Modification to Approved Project
City of Rochester, New Hampshire

Case # 216-11-GRD-14 Property Address 92 Farmington Road

Project name The Ridge Marketplace

PROPOSED CHANGES TO OVERALL
SITE PLAN

OVERALL SITE PLAN

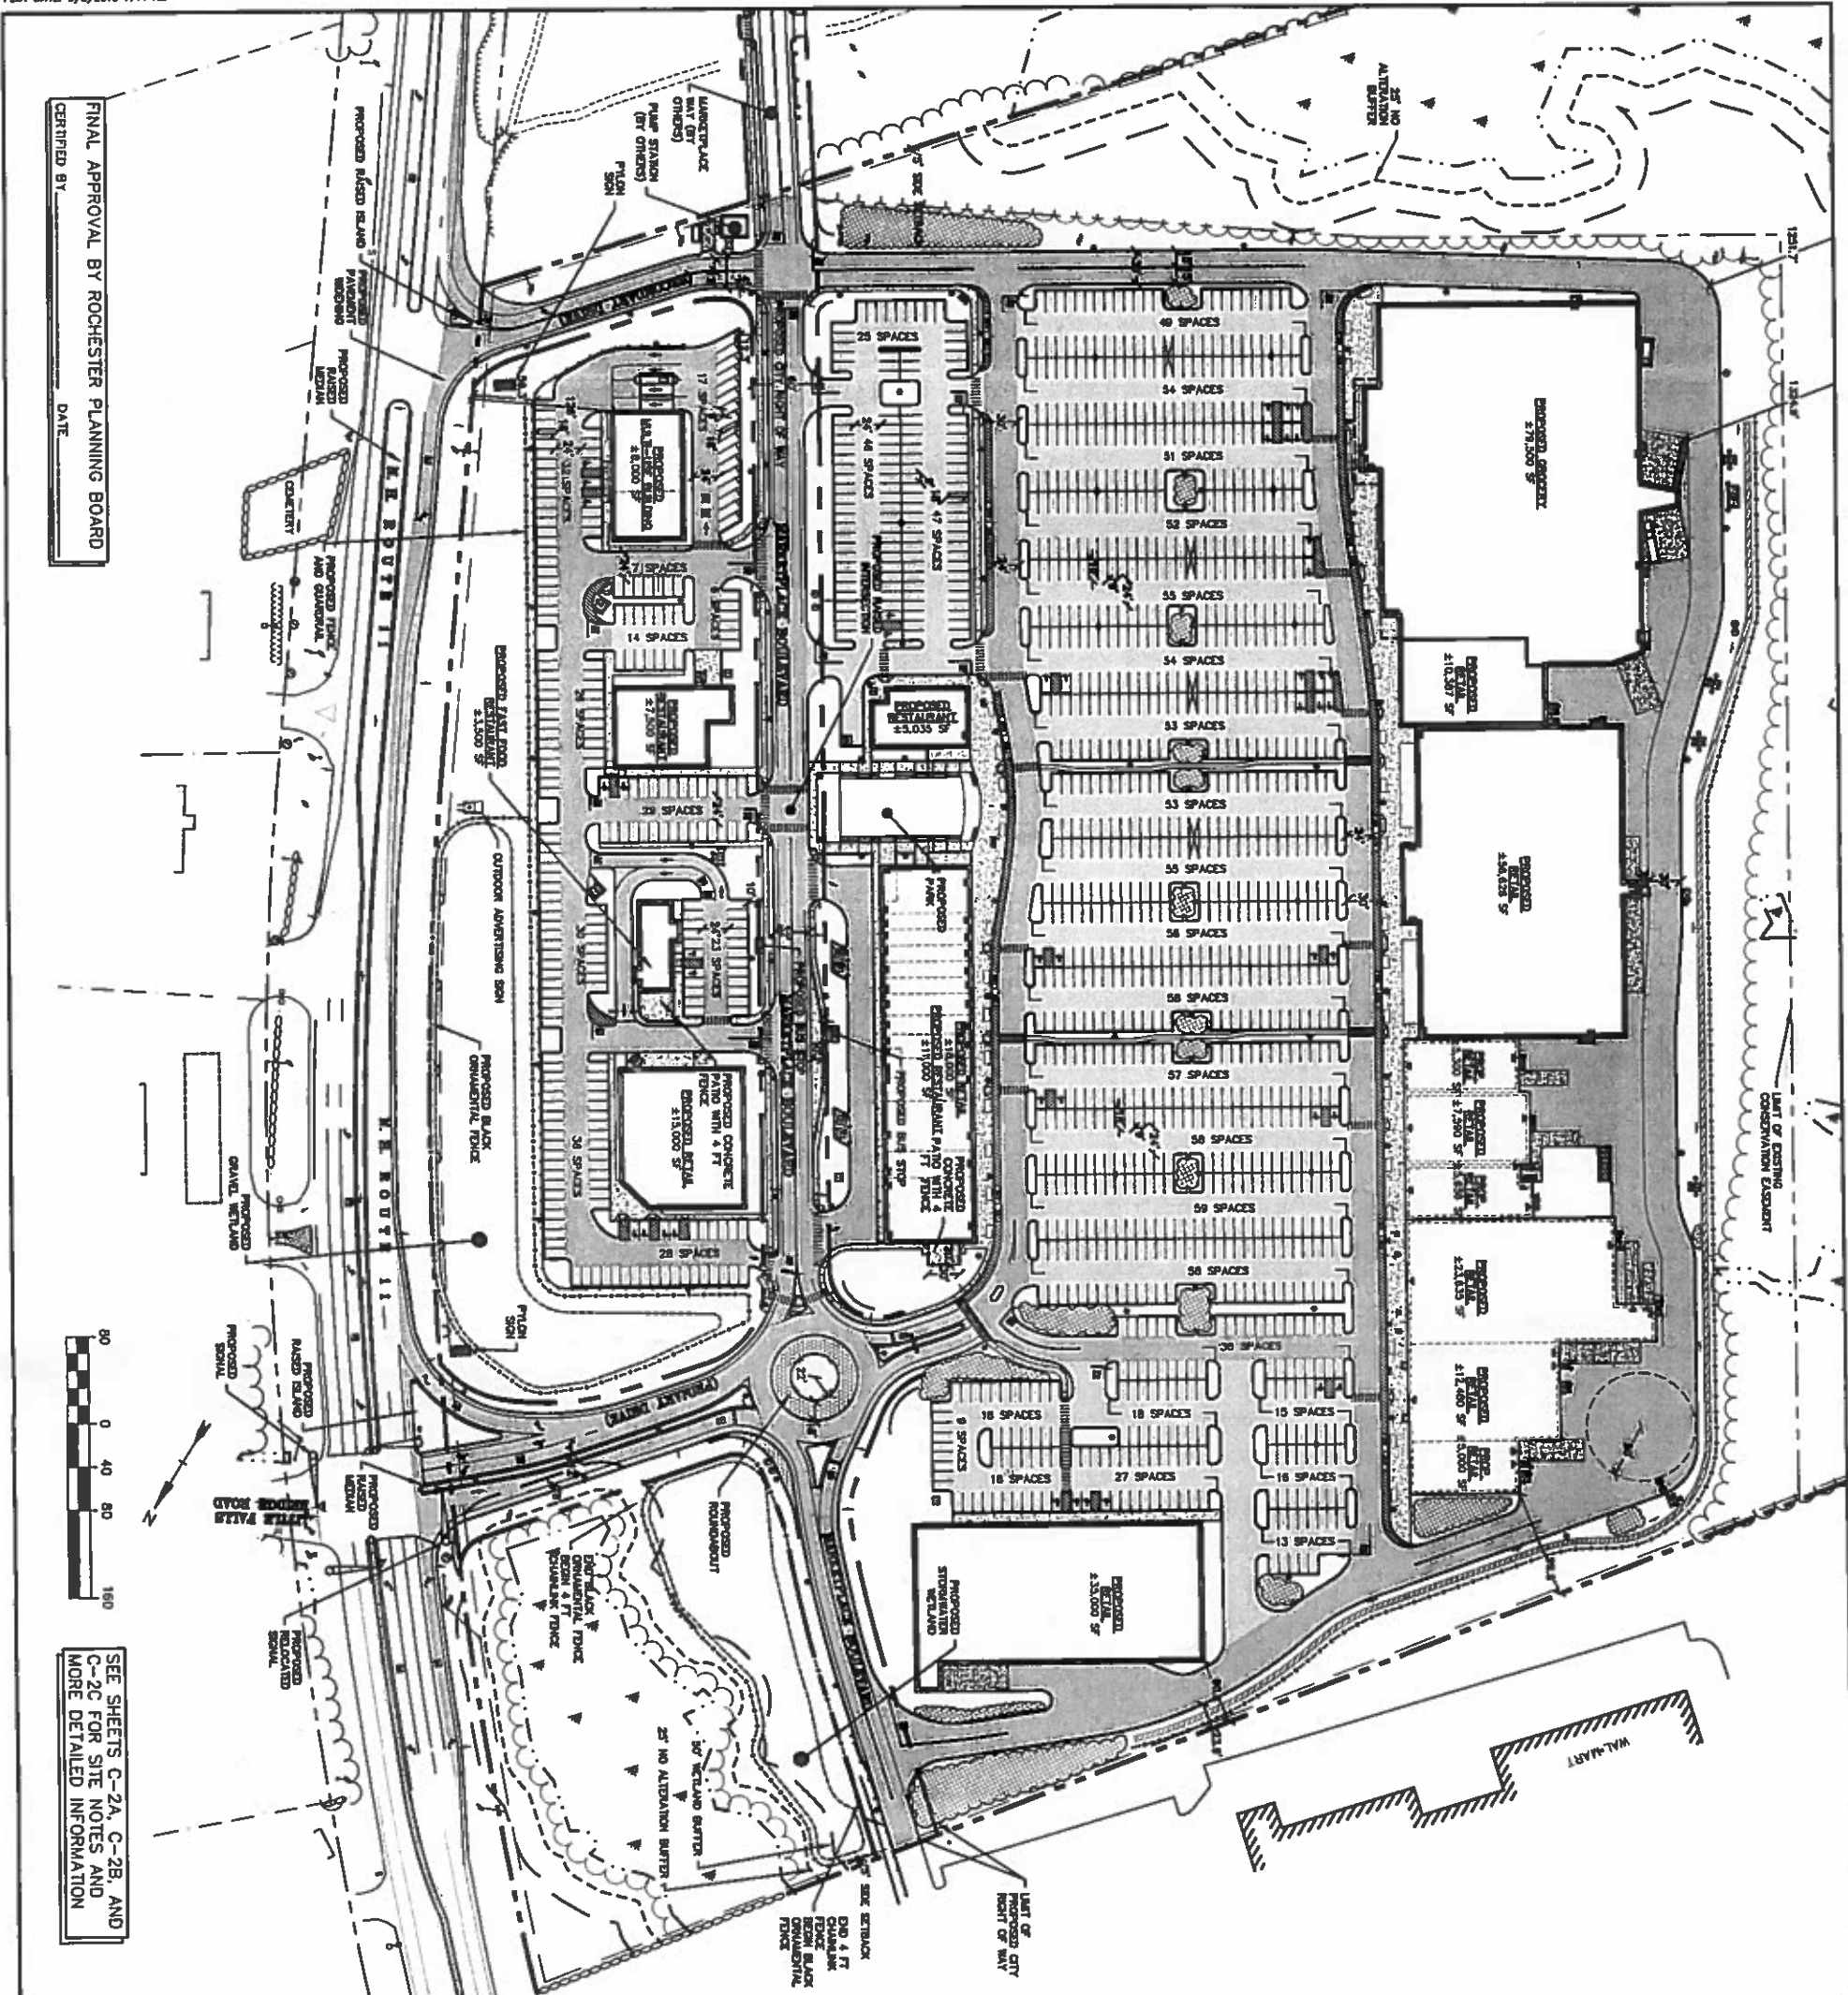
- Building Footprint Changes:
 - o The total proposed building square footage increased from +/-290,582 sf to +/-309,209 sf.
 - Minor modifications have been made to some tenants in the "Anchor" building on the western side of the development.

- The demising wall on the southernmost tenant has been removed per tenant request.
 - Two dedicated utility rooms have been added to the rear of the development per tenant requests.

- The 17,000 sf retail building has been replaced with a 35,000 sf retail building.
 - The Utilities, Drainage, and Landscaping in the vicinity of this building will be revised to accommodate the expanded building.

- Additional Wetland Impacts
 - o Approximately 8,250 sf of wetland impacts are required for the above mentioned 35,000 sf retail building. The size of the wetland is less than one half of an acre and thus the area is exempt from the regulations under the City's Zoning Ordinance Section 42.12 Conservation Overlay District (42.12.e).

- Parking Lot Revisions:
 - o The total parking proposed increased from 1,346 to 1,358 spaces (4.39 spaces per 1000 sf of GFA proposed).
 - o Additional accessible parking spaces and cart corrals have been added in front of the "Anchor" building's southernmost tenant per the tenant's request. These changes also require modifications to the islands at the end of the parking fields.

- Landscape Revisions:
 - o Eight (8) additional 5'x12' raised planters have been added to the pedestrian area in front of the 29,000 sf strip building.

- o The park area at the center of the site has been revised to reduce the amount of concrete sidewalks and increase the amount of landscaped planters.

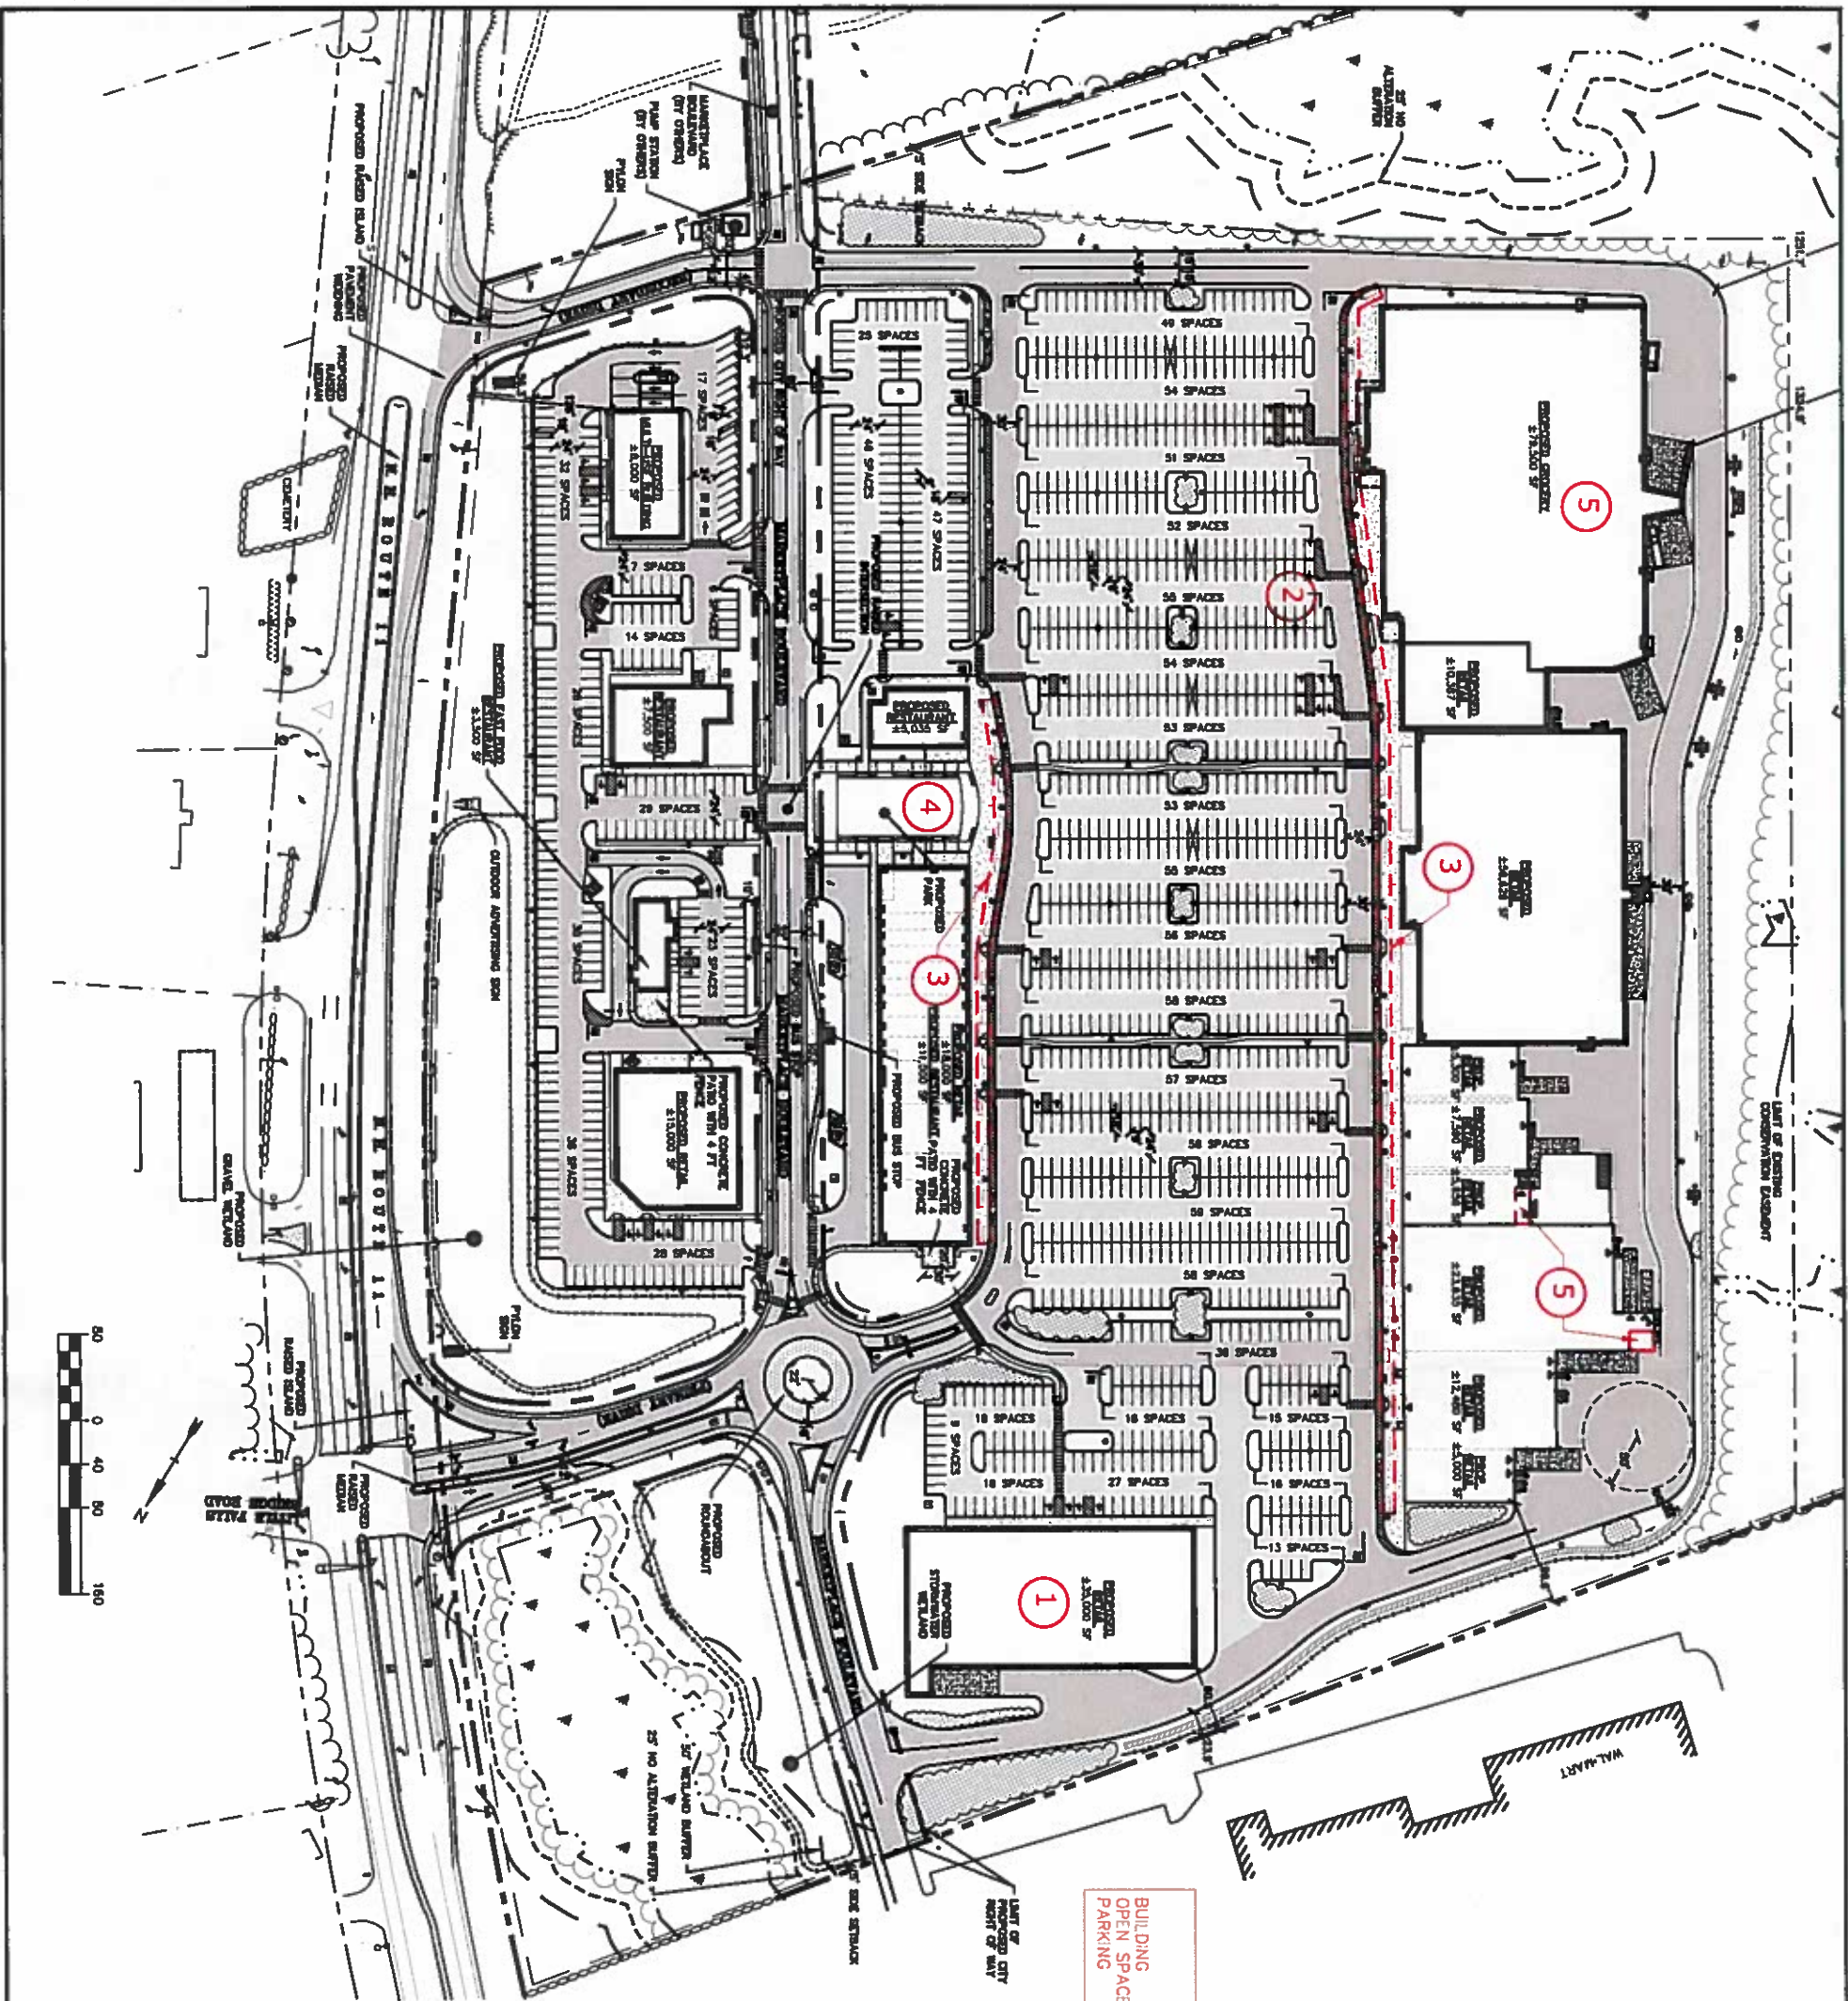
PROPOSED SITE LAYOUT REVISIONS TO
APPROVED SITE PLANS DATED MAY 19,
2015.

- (1) BUILDING MODIFICATIONS AND ASSOCIATED IMPACTS
 - REVISE BUILDING FOOTPRINT AND ASSOCIATED PARKING LAYOUT PER TENANT REQUEST (SEE CHART BELOW FOR CHANGE IN SF).
 - RELOCATE INFILTRATION AREAS.
 - FILL ± 8,520 SF OF FLAGGED WETLAND AREA.*
- (2) MAIN PARKING FIELD MODIFICATIONS
 - REVISE GEOMETRY OF RAISED AND PAINTED ISLANDS PER TENANT REQUIREMENTS.
- (3) LANDSCAPE REVISIONS
 - REVISE LAYOUT AND NUMBER OF PLANTERS ALONG SIDEWALKS (ADDED 8 - 5'x12' PLANTERS)
- (4) PARK REVISIONS
 - SIDEWALK AREAS HAVE BEEN REDUCED TO ALLOW FOR ADDITIONAL PLANTING AREAS.
- (5) MINOR FOOTPRINT CHANGES
 - DEMISING WALL ELIMINATED PER TENANT REQUEST.
 - ADDED 2 UTILITY ROOMS AT THE REAR OF THE ANCHOR BUILDING PER TENANT REQUEST.

290,582 SF | 309,209 SF | +18,627 SF |

1,346 SPACES | 1,358 SPACES | +12 SPACES |

*8,520 SF OF WETLAND AREA WAS DELINEATED BY GOVE ENVIRONMENTAL SERVICES, INC. ON AUGUST 24, 2015. APPLICANT IS SUBMITTING APPLICATION TO THE NHDES SIMULTANEOUSLY FOR THIS WETLAND IMPACT.
